Class 2 Permit Modification Request

Revise Waste Analysis Plan Waste Characterization Methods

Waste Isolation Pilot Plant
Carlsbad, New Mexico

WIPP Permit Number - NM4890139088-TSDF

Figure C-2
Waste Characterization Process

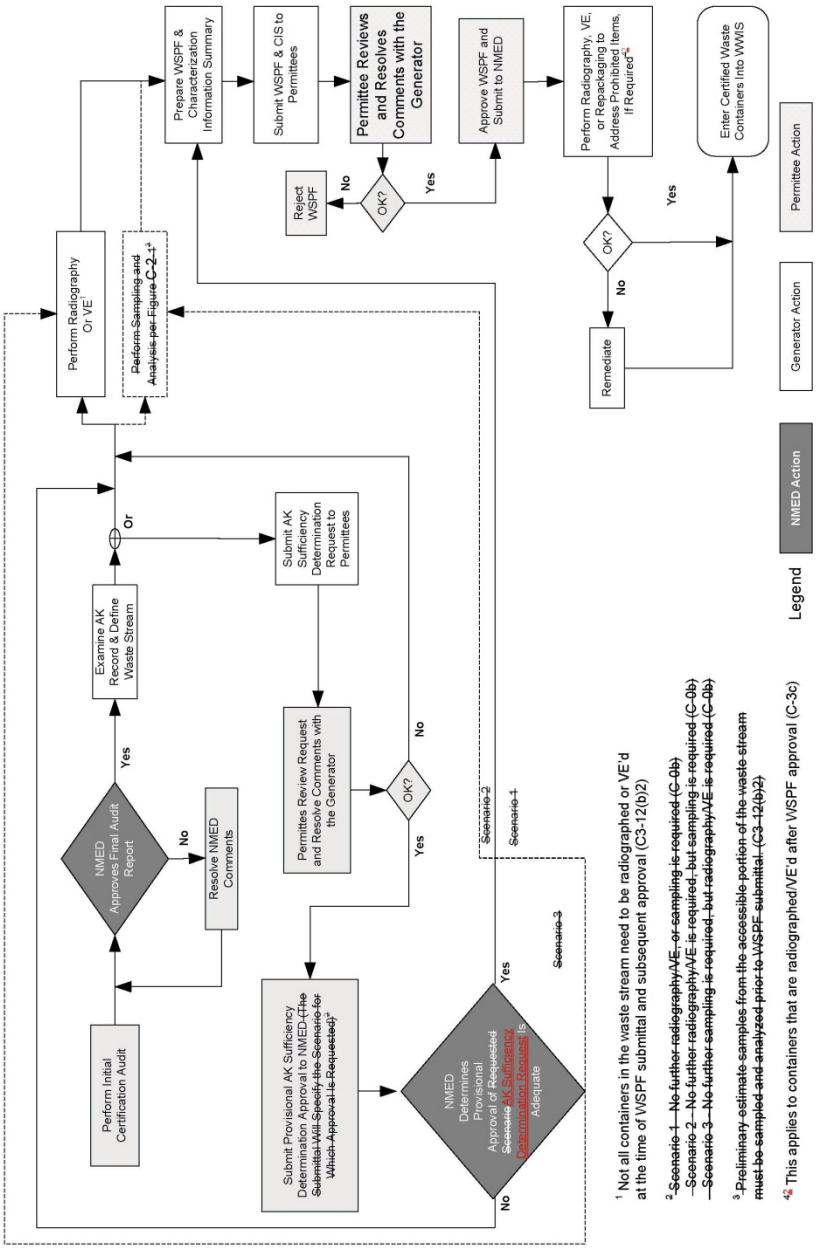
[2] ~~Scenario 1 - No further radiography/VE, or sampling is required (C-0b)~~
~~Scenario 2 - No further radiography/VE is required, but sampling is required (C-0b)~~
~~Scenario 3 - No further sampling is required, but radiography/VE is required (C-0b)~~

[1] Not all containers in the waste stream need to be radiographed or VE'd at the time of WSPF submittal and subsequent approval (C3-12(b)2)

Figure C4-2
Acceptable Knowledge Auditing

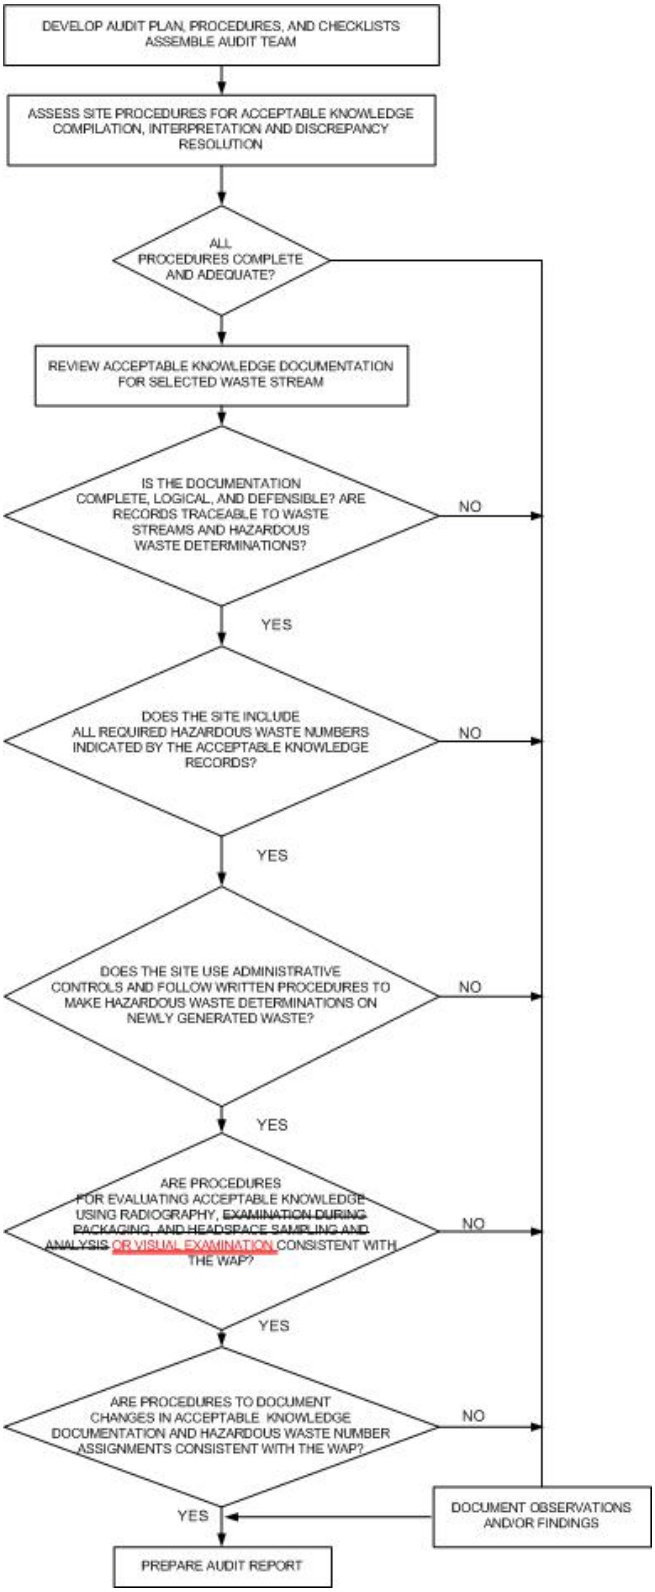
Attachment C4, Section C4-3f	Replaced one instance of sampling and analysis with testing and replaced in one instance analytical with testing.
Attachment C4, Figure C4-2	Replaced in one instance the text *examination during packaging, and headspace sampling and analysis* with *or visual examination*.
Attachment C5, Section C5-2	Deleted one reference to sample handling and custody requirements and deleted one reference to sample acceptance criteria. Replaced in one instance sampling and analytical with testing.
Attachment C6, Section C6-1	Deleted four references to DOE approved laboratory and replaced in one instance sampling and analysis with testing.
Attachment C6, Section C6-2	Deleted one reference to DOE approved laboratories.
Attachment C6, Section C6-3	Replaced one instance of analysis with testing and one instance of sampling areas and equipment, analytical laboratories with waste testing facilities. Deleted two references to DOE approved laboratory.
